ENERGY UPGRADES
MILFORD COURTHOUSE
MILFORD, CONNECTICUT
PROJECT: BI- 2B - 315

BID OPENING	**1:00 P.M.**	**MARCH 31, 2010**
ADDENDUM NUMBER 4	**DATE OF ADDENDUM**	**MARCH, 25, 2010**

BID OPENING	**1:00 P.M.**	**MARCH 31/2010**
ADDENDUM NUMBER 2	**DATE OF ADDENDUM**	**MARCH, 18, 2010**

BID OPENING	**1:00 P.M.**	**MARCH 31, 2010**
ADDENDUM NUMBER 1	**DATE OF ADDENDUM**	**MARCH, 18, 2010**

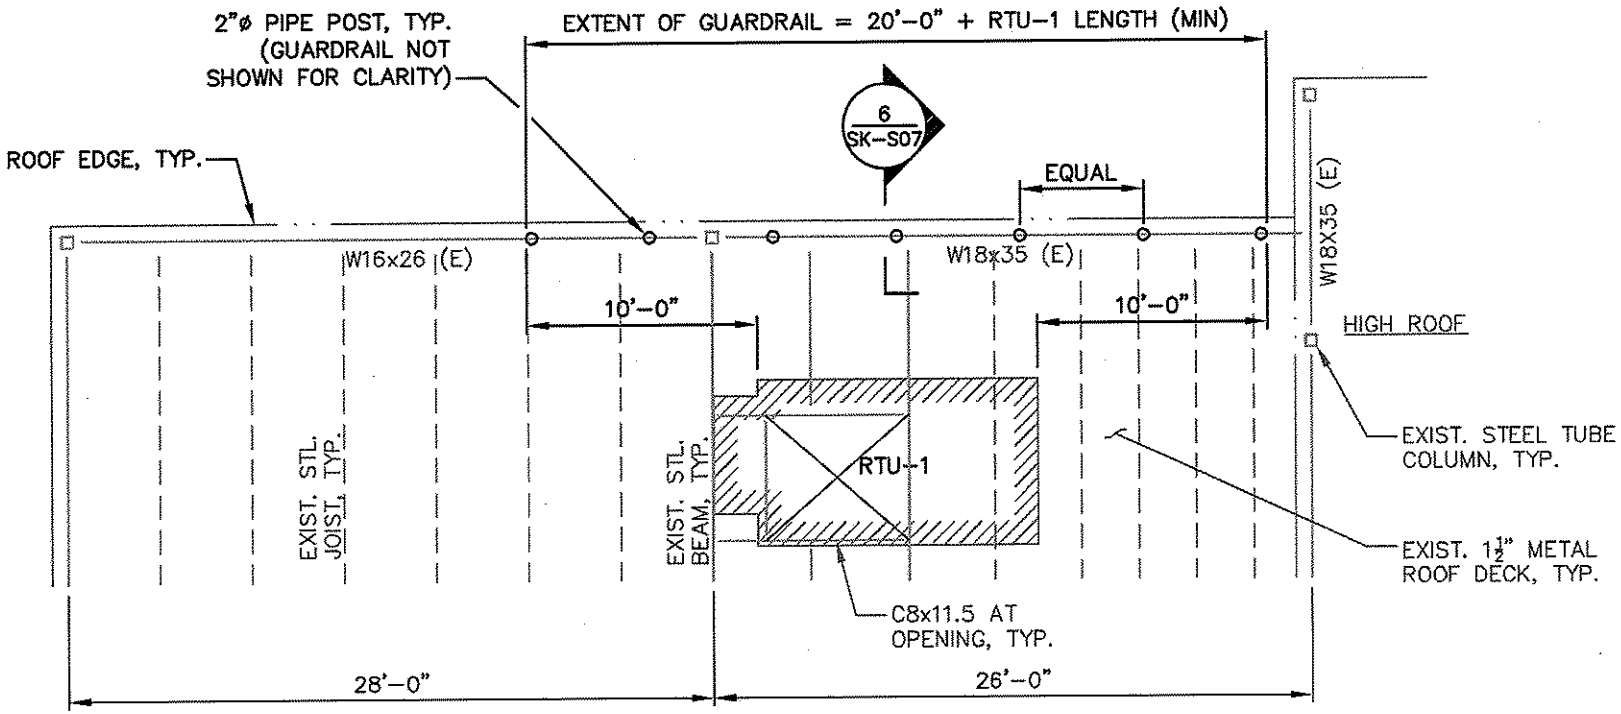
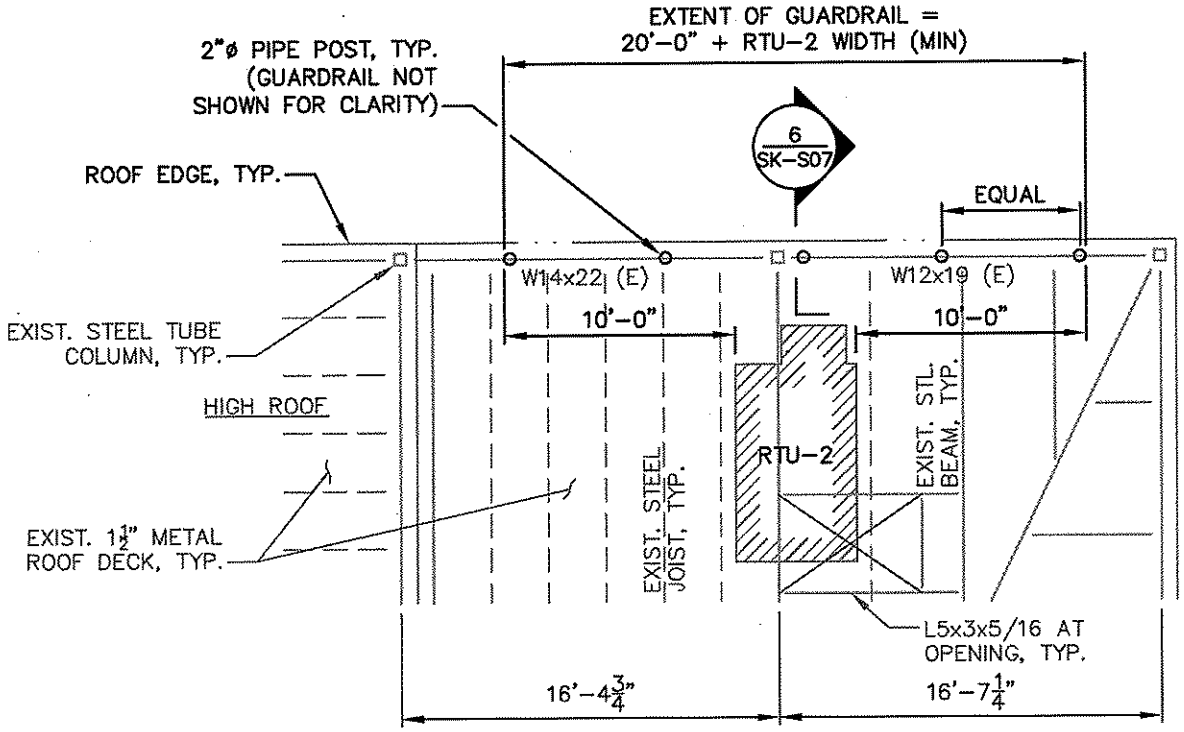
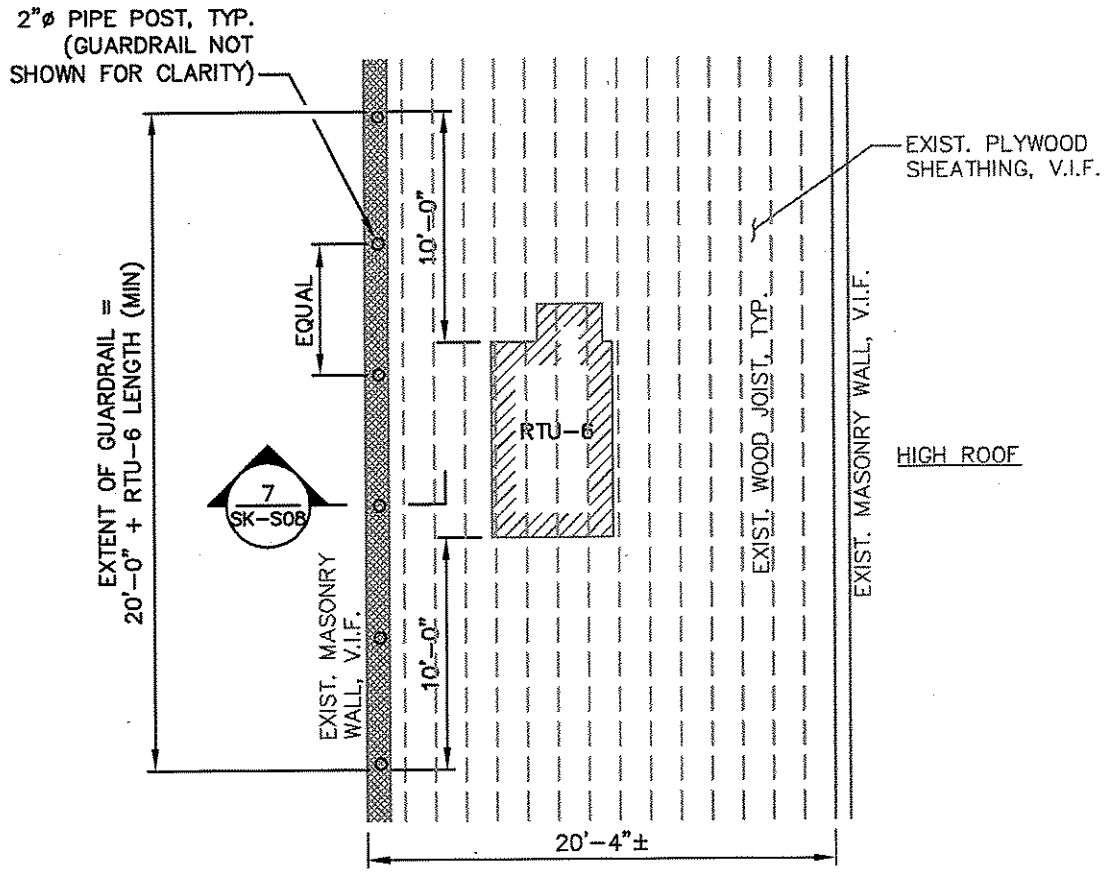
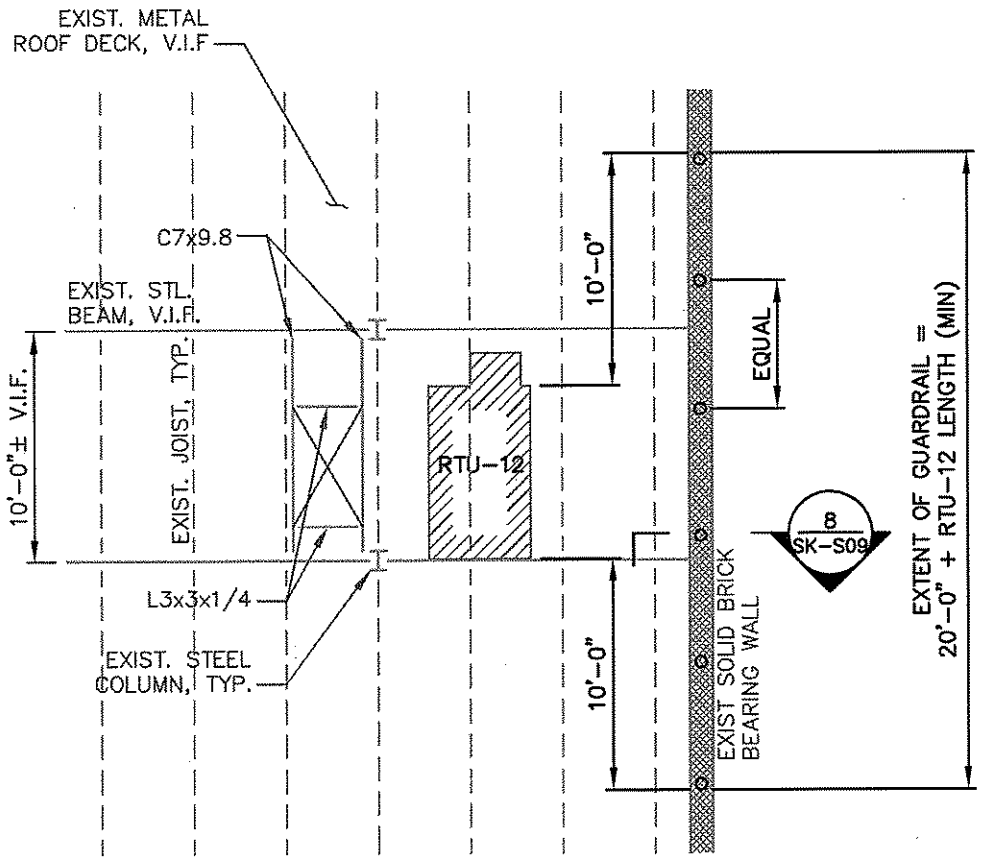
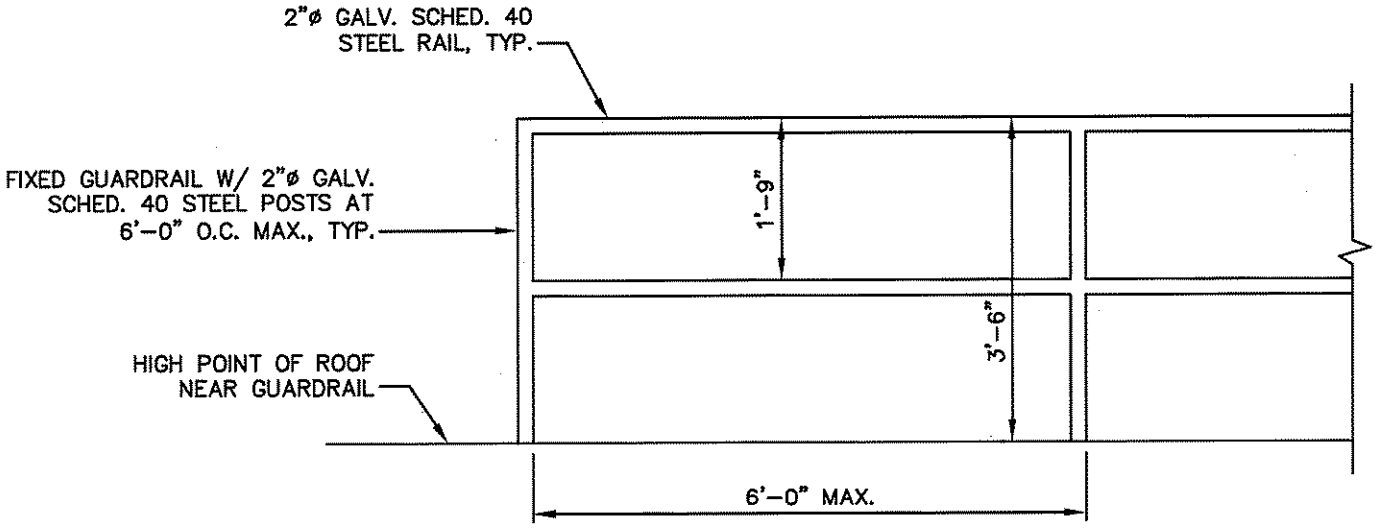
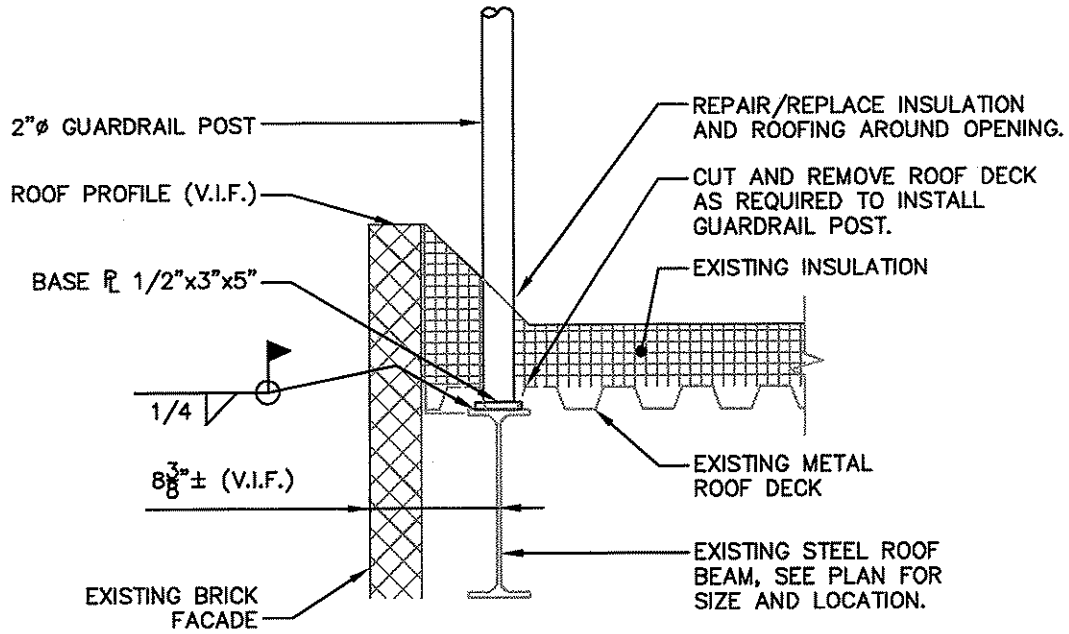
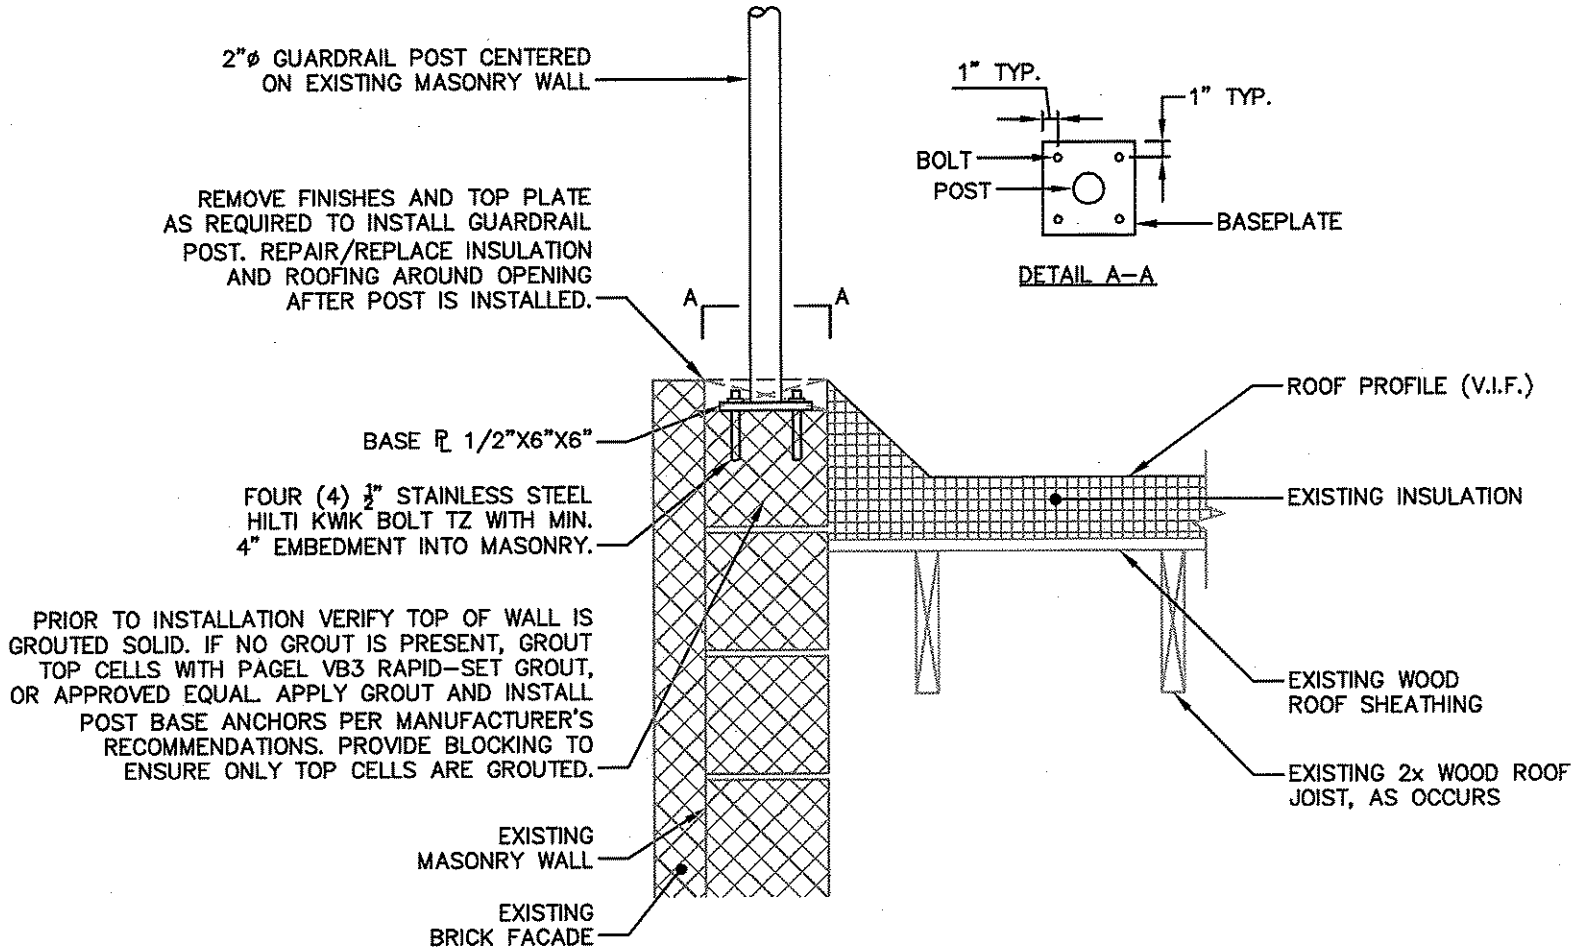
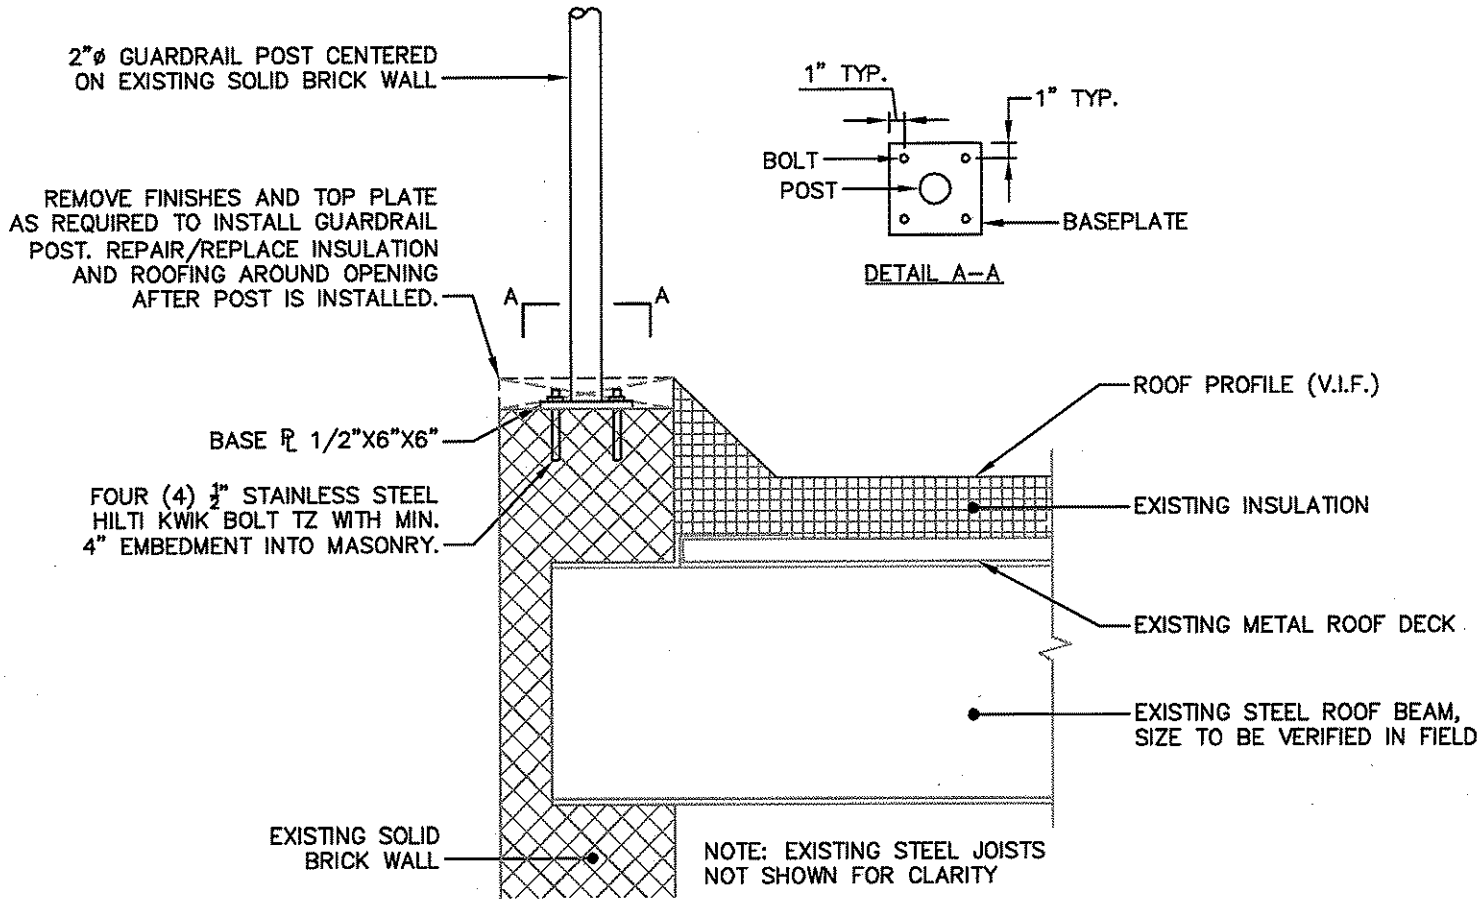
Add scope of work to drawing M-1.3 indicated by attached sketches SK-S01 thru SK-S09.
